Re: FCC ID QLA100MHZ
Applicant: Mala GeoScience AB (publ)
Correspondence Reference Number: 26606
731 Confirmation Number: EA546722

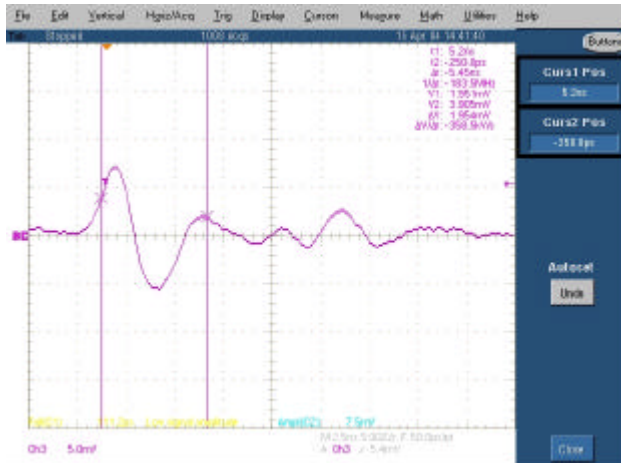
1. What is the pulse width?

As can be seen in the figure below, the pulse width is approximately 6ns, measured with a small antenna probe, in air.
